Appendix A

Comments and Responses

This appendix contains agency and public comments received on the SH 82/Grand Avenue Bridge Environmental Assessment during the 60-day comment period (October 31, 2014 through December 31, 2014). Agency comments are presented first, followed by public comments received at the November 19, 2014 public hearing (including verbal and written comments), and other written public comments received during the comment period. Note that letters to the editor printed in local newspapers were not considered comments submitted on the Environmental Assessment (EA), unless the letter was also submitted to the Colorado Department of Transportation (CDOT) as official comment on the EA. Responses are provided beside each comment.

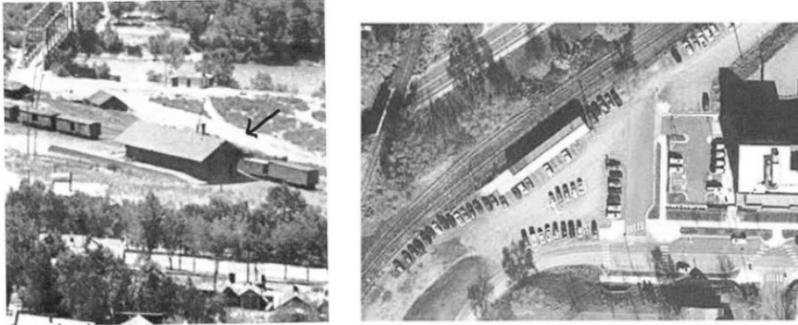
5ea	3-11 The EA should address the visual impact of the 25 foot tall retaining walls, and the impact of walls that are 562 feet in length. Walls that are located within public or pedestrian areas need to include treatments that add shadows and that have some visual interest. Long expanses of flat, mono-colored walls should not be acceptable as they are uninteresting and will become a magnet for graffiti. Form liners and sand blasted walls as suggested on page 3-22 should not be part of this project.	Please refer to Figure 3-6 of the EA that presents the aesthetic treatments for retaining walls currently being evaluated with the City and other stakeholders. CDOT is committed to including aesthetic treatments in retaining walls to mitigate their visual impact. Aesthetic treatments for retaining walls vary based on their location and setting. Please refer to Section 4.1 of the FONSI for more information.

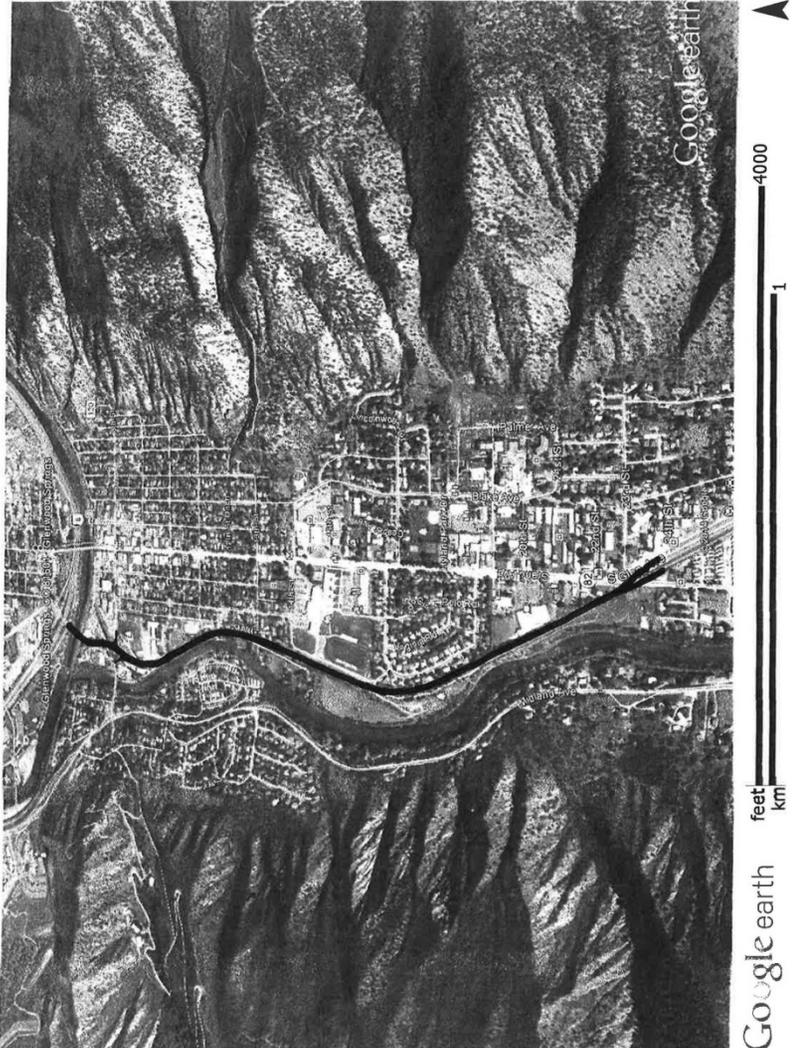
Comment No.	Comment	Response
<p>134</p> <p>134a</p>	<p>Comment # 134: Rich Traver</p>  <p>A rendering from the Grand Avenue Bridge Environmental Assessment gives a general idea how the newly aligned Highway 82 bridge would tie into the Interstate 70 interchange and intersection at Sixth and Laurel.</p> <p>Might this Prove to be the World's Most Expensive Parking Lot?!!!</p> <p>With all of its extremely complex traffic interactions, and while introducing its own new array of traffic frustrations, it still doesn't address the real problem! Though addressing the narrow <u>old Bridge</u> across the Colorado River issue, it still dumps all the usual traffic onto Grand Avenue through downtown, which is the perpetual bottleneck. This traffic must and will increase over time as the Roaring Fork Valley grows bringing the unresolvable congestion with it.</p> <p>With the majority of the traffic removed from the old US-24 to/from West Glenwood with its Motels, Restaurants and Amusements, and with exiting traffic bypassed from 5th Street, WHY any roundabout would be necessary is a mystery, other than to exhibit the in-vogue engineering fashion trend of the day.</p> <p>A further long-term problem in the city is the matter of there being only ONE bridge across the river, except for one other (with very limited capacity) three miles west at the West Glenwood Exit of I-70. If either bridge is unusable for whatever reason, the entire City and all towns to the south are drawn into inescapable traffic snarls. This is an entirely intolerable and inexcusable situation. But, the above proposal does not effectively resolve any of this.</p> <p>While the above posed "solution" addresses one consideration, it ignores the REAL problems:</p> <ol style="list-style-type: none"> 1. Only one bridge across the river – and only one after this project is complete, and 2. The clogged traffic on Grand Avenue once all traffic is dumped onto it from its new bridge. <p>Glenwood Springs happens to be blessed with a situation that is unique and nearly perfect to address the real problem of too much traffic passing through its downtown main artery. The abandoned railroad right-of-way of the old Aspen Branch offers a clear route for a bypass, removing through non-stop traffic from towns to the south that have no interest in travelling the route other than it being the ONLY way to get out of the Roaring Fork Valley and to access the Interstate highway.</p> <p>The accompanying sketches poses one suggestion for using this feature of the area, providing a clean bypass for out-of-town through traffic as well as providing a second bridge across the river while the old bridge (which will remain as it is presently) is repaired. Reduced non-stopping traffic from the City streets will make the downtown area a much more desirable environment for commerce than the frustrating experience it is today due to over congestion.</p> <p>The "problem" is much bigger than just an interchange and bridge, and this DOT plan solves neither.</p>	<p>Comment #134a Response: Please refer to Comment #133n Response above regarding use of the Denver & Rio Grande Railroad - Aspen Branch. Also, refer to Comment #9b Response regarding a SH 82 bypass or reroute, and Comment #12a Response regarding the scope of the study. Refer to Comment #80a Response regarding your comments on the purpose and need. Refer to Comment #13b Response regarding the bridge's ability to effectively serve future (2035) transportation demand. Regardless of whether a bypass or alternate route is constructed in the future, the deficiencies of the Grand Avenue Bridge need to be addressed.</p>
